Appendix 4.7

Mirrlees Assessment Report

Yukon Energy KV-16 August 2016 Inspection

WD3 KV-16

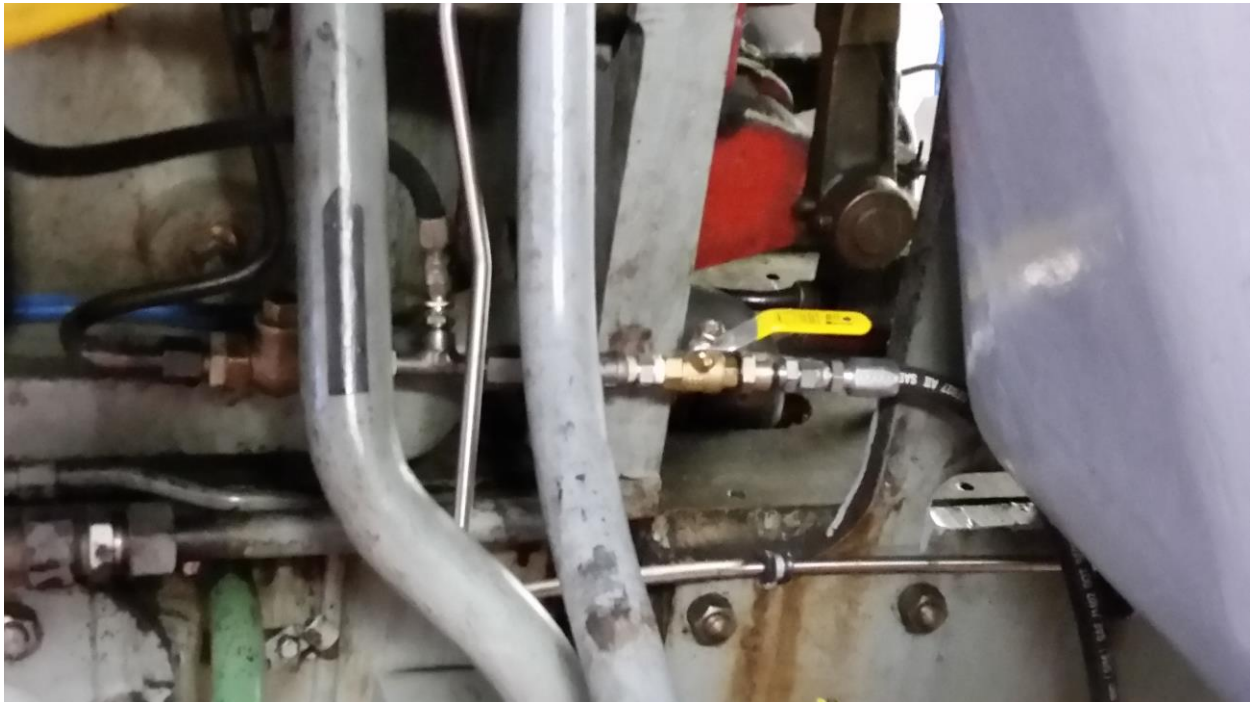
The lubricating rocker pressure regulator was removed from WD2 to replace the manual valve that was installed at the last overhaul. This valve was found to be defective and the manual valve was reinstalled. (This regulator valve could not be sourced by MAN at the last overhaul.)

The engine did not start at first attempt; some fuel pumps were sticking.

Engine started to overheat, jacket water cooling system was up to 200° F.

No alarm came on; **needs to checked.**

‘A’ bank was up to 150° F and the alarm came on.

‘B’ bank was running at 138° F with no alarm.

The secondary cooling system uses untreated river water and the engine pipe work and valves look original and could be over 45 years old.

The overheating problem could also be restrictions in the pipe work due to 45 years of scale build up. The scale could also be blocking the plate type heat exchangers. Cleaning and inspections of the plate heat exchangers is a one to two-week job with parts.

The raw water pump may not be operating properly. There is also a possibility of a closed valve in the system due to WD1 and WD2 taken out of service.

The pump taken out of service should be checked to make sure it is operational.

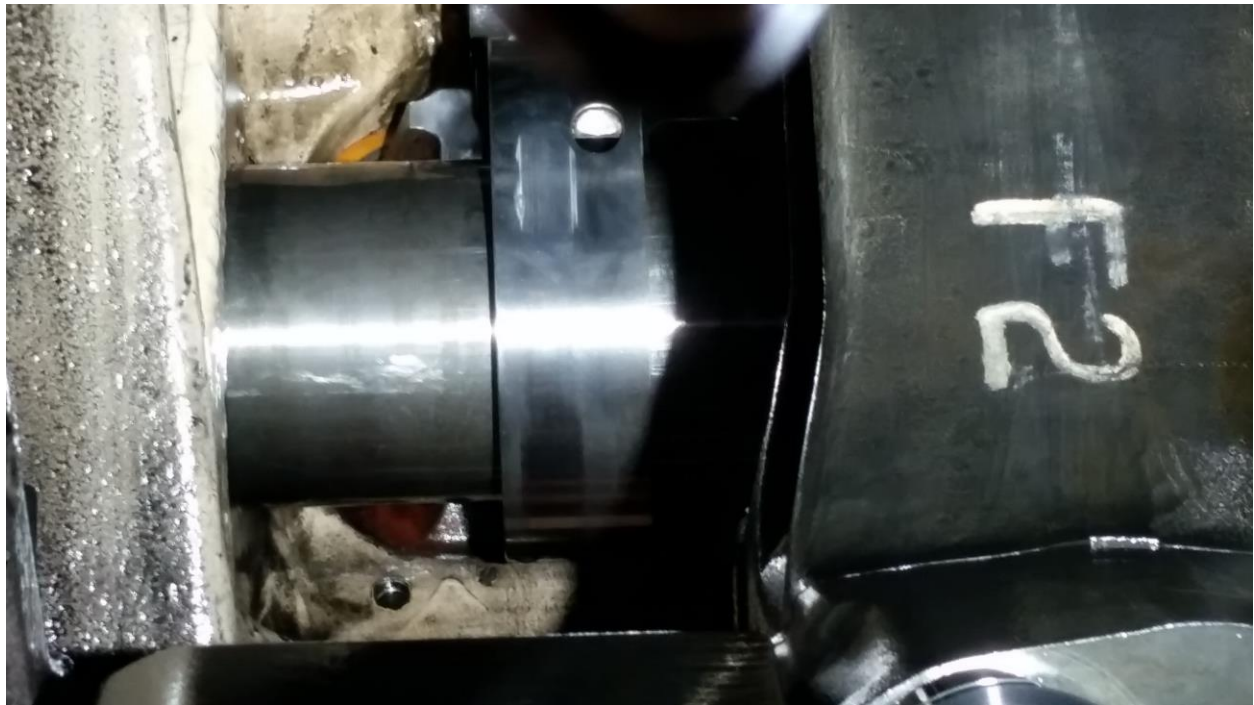
Visual signs of B6 exhaust cam (K22448) picking up. B6 crankcase door was removed.

Unable to inspect further due to type of clearance on the unit.

Bottom of cylinder liners that could be seen are showing signs of polishing.

The extent of the polishing is not known and can be caused by the short runs or the liners not properly honed at the time of the last overhaul.

Operations noted that the gear train is extremely noisy in the winter months, which could be caused by engine foundation movement. The original grout that is installed is prone to crumbling due to the type used at the time of installation.

There was no overhaul report submitted to Yukon Energy from DEAS, so there is no record of tolerances (liners, piston grove clearances, gear backlash). This could have a major impact on future parts requirements, down time, and costs.

Recommend removal of cam door for more detailed inspection. If the cam needs to be replaced, this job could take up to a month after the parts are sourced.

Recommend that crankshaft deflections be taken in beginning of spring, the middle of summer, fall, and the middle of winter to see if there is crankshaft and bedplate movement. Inter-gear clearances should be checked at the same time.
This job is about one week.

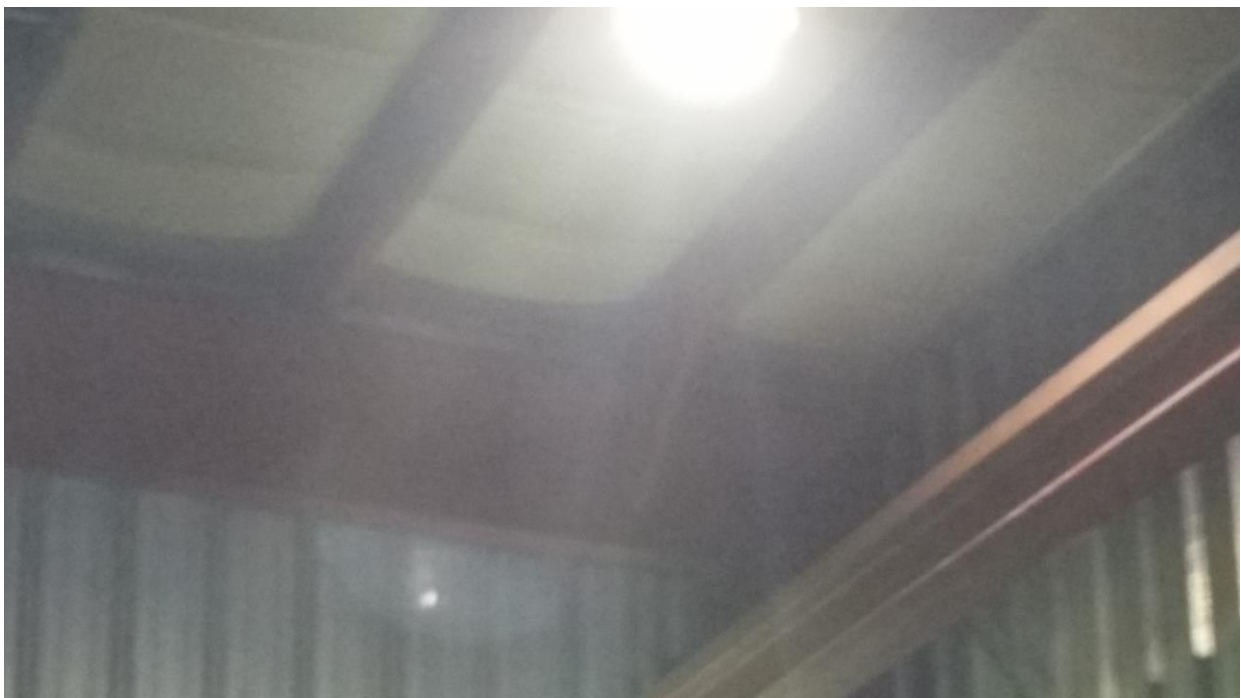
Mechanical emergency over-speed and low lube oil pressure trip shutdown blocked with a wedge. It was found that the unit trips off when running.

This could have a catastrophic failure if there is a governor failure.

Misalignment of the tripping lever mechanism is caused by movement of the cylinder block.

The mechanical overspeed trip and low lube pressure is now not operational and is relying on the electrical shut downs

Realignment of the tripping mechanism is needed; this could take up to a month to correct.
